Preliminary Consultation
MONTGOMERY COUNTY HISTORIC PRESERVATION COMMISSION
STAFF REPORT

Address:	7400 Wisconsin Avenue, Bethesda	Meeting Date:	5/9/2018
Resource:	Master Plan Site #35/014-005A Bethesda Post Office	Report Date:	5/2/2018
Applicant:	7400 Wisconsin LLC	Public Notice:	4/25/2018
Review:	Preliminary Consultation	Tax Credit:	No
Case Number:	N/A	Staff:	Michael Kyne
PROPOSAL:	Retroactive site wall alterations and other site alterations

ARCHITECTURAL
SITE PLAN

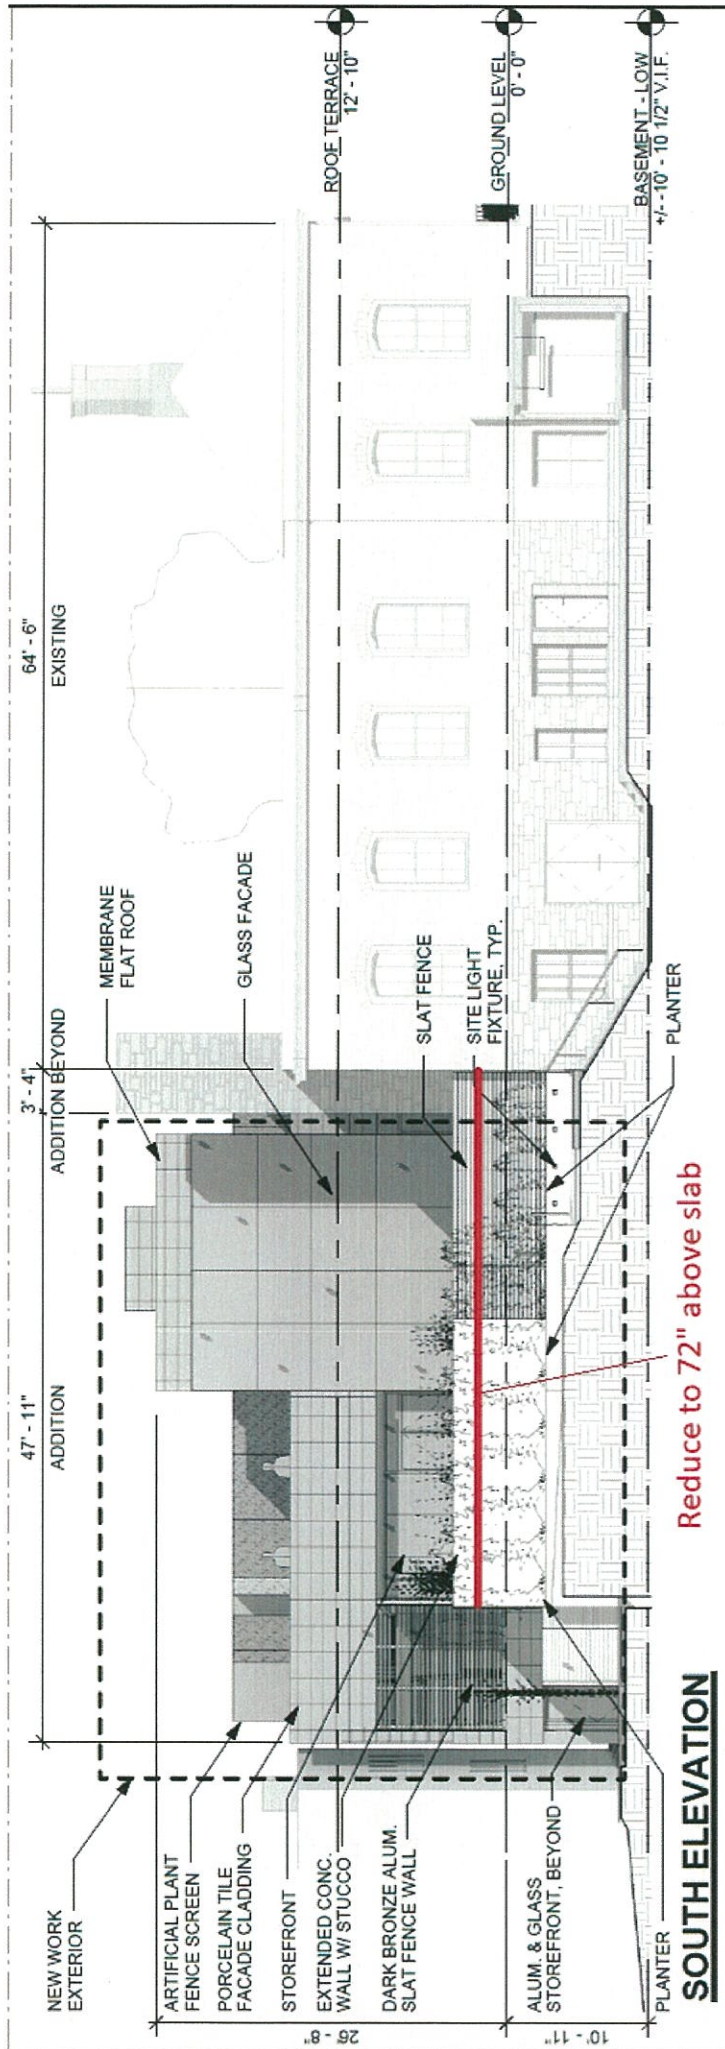
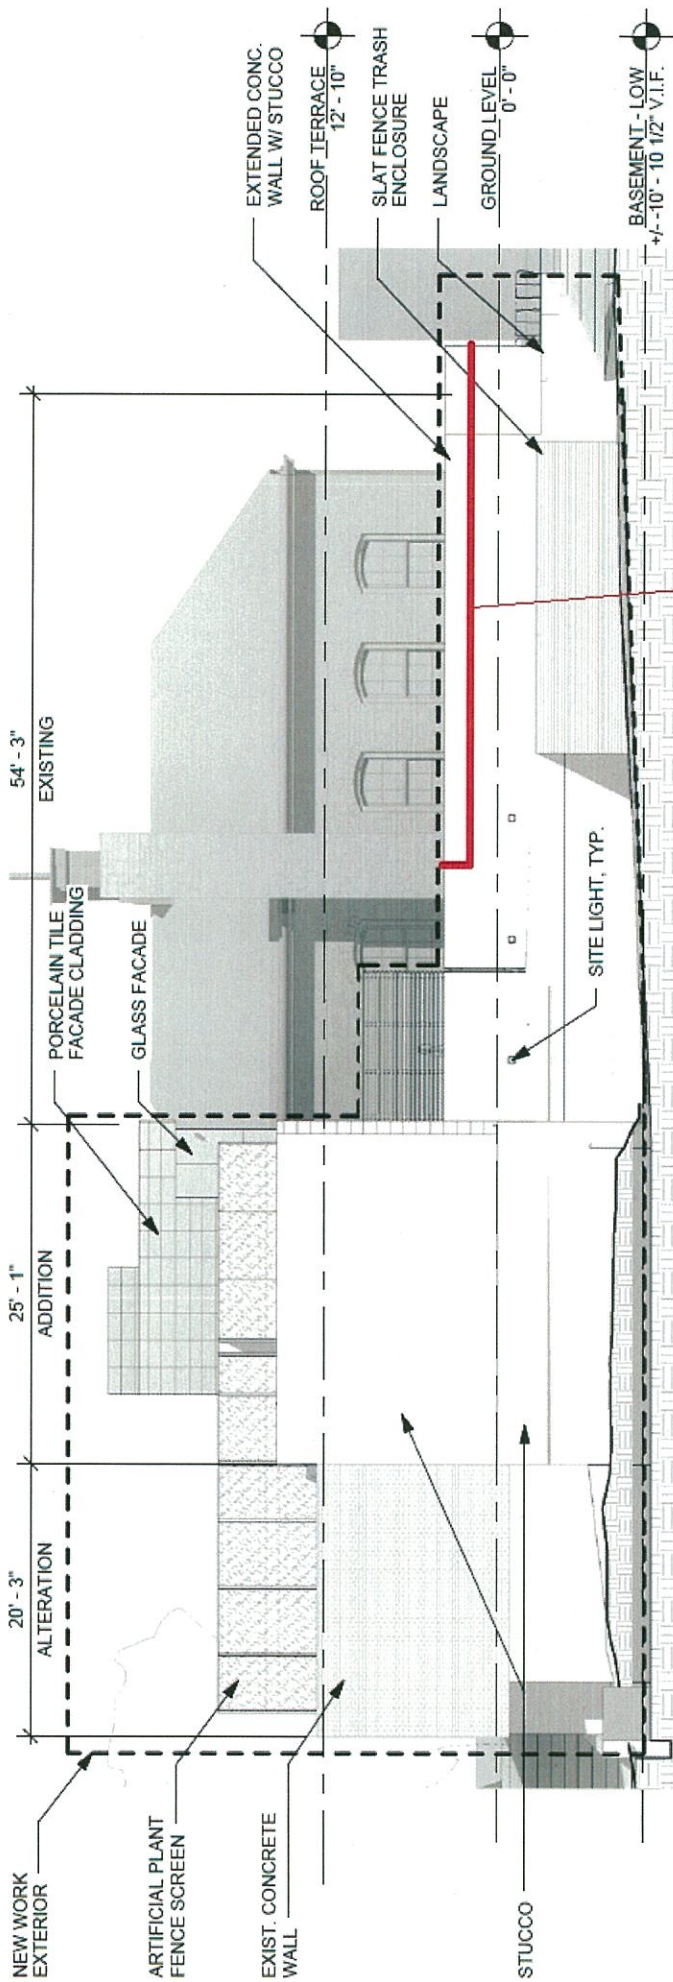
Staff finds that the concrete site wall and horizontal slat fence/gate, as currently constructed, are incompatible features that detract from the resource. These features at least partially obscure the rear elevation of the historic building and prevent its character-defining features from being experienced from Montgomery Lane. The applicants are proposing to reduce the height of the site wall and fence to 6', which is consistent with the Commission's height requirements for fences and site walls behind the rear plane of a historic building; however, as noted above, the special consideration should be given for this corner lot property, as a solid 6' tall site wall has the potential to obscure character-defining features on the rear of the historic building.

Staff also notes that, when viewing the subject property from Montgomery Lane, the overall perceived height of the site wall (the proposed 6' tall site wall on top of the existing 4' tall retaining wall) will be 10'. To be consistent with the Commission's height requirements for site walls and fences, the proposed site wall could be no higher than 2'. While this would result in a site wall that is perceived to be 6' tall from the public right-of-way on Montgomery Lane, it will not provide the desired privacy for the enclosed garden plaza/exercise space. As noted above, the objective in this case is to preserve the visibility of rear windows and the rear elevation of the historic building from the public right-of-way of Montgomery Lane. Staff finds that a compatibly designed site wall that preserves the visibility of the windows from the public right-of-way is appropriate at this site, even if the perceived height of the site wall exceeds 6'.

Staff recommends further mitigation, which might include reducing the height of the concrete site wall and horizontal slat fence/gate to 4', as previously approved for the cable rail fencing. The applicants have expressed concerns about the security of a wall less than 6' tall. However, alternatives, such as a 2' tall cable rail fence on top of a 4' tall concrete site wall and existing 4' tall concrete retaining wall, may address these security concerns while preserving the visibility of the character-defining features (i.e., windows) at the rear of the historic building.

- Staff recommends that the height of the concrete site wall and horizontal slat fence/gate be further reduced to be no higher than 4' on top of the existing 4' tall concrete retaining wall. An additional 2' of semi-transparent screening (i.e., cable or metal rail fencing) on top of the concrete site wall

is appropriate to a total height of 6' (with a total perceived height of approximately 10'), keeping the total height of the enclosure below the rear window sills.

1 ROOF PLAN - DECK
3/32" = 1'-0"

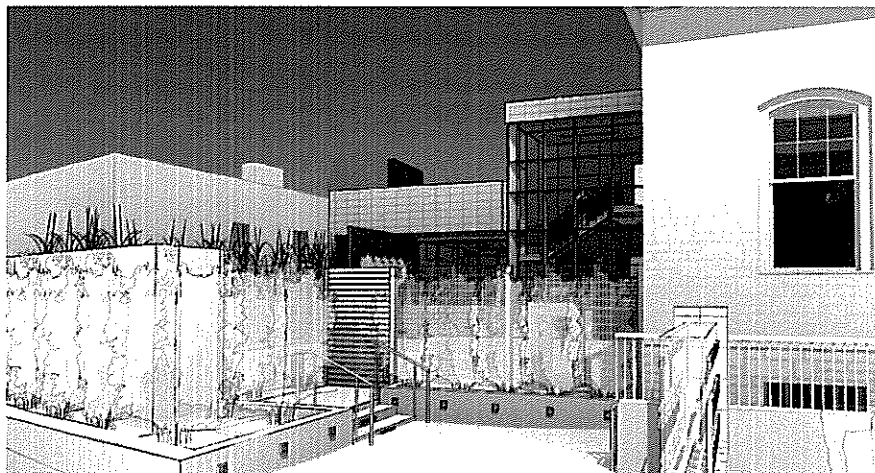
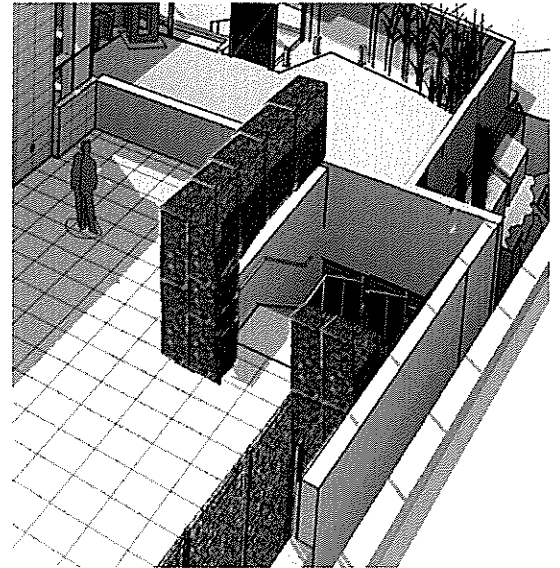
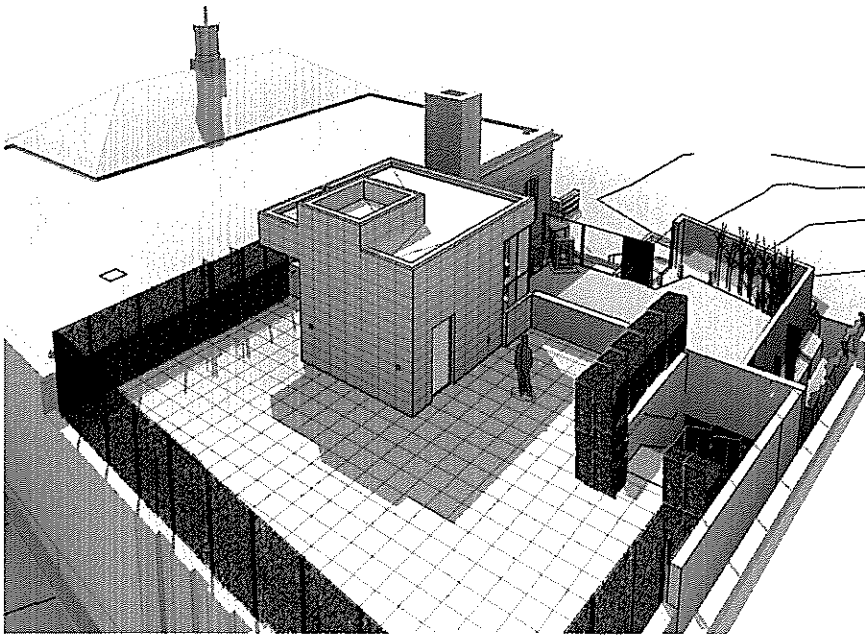
Although the chain link fence with artificial plant screening on the roof of the rear addition is not consistent with the Commission's policy – and staff is concerned that the fence was constructed without a HAWP – it will not detract from character-defining features of the historic site, due to its location on the roof of a rear addition. Likewise, the garden patio will not detract from the resource, as this is an at-grade feature in the former location of a paved parking lot.

- Staff recommends that the Commission support the retroactive garden plaza proposal.
- Staff recommends that the Commission support the retroactive rooftop fence with artificial plant screening proposal.
- Staff recommends that the applicant make any revisions based on the HPC's recommendations and return for a HAWP application.
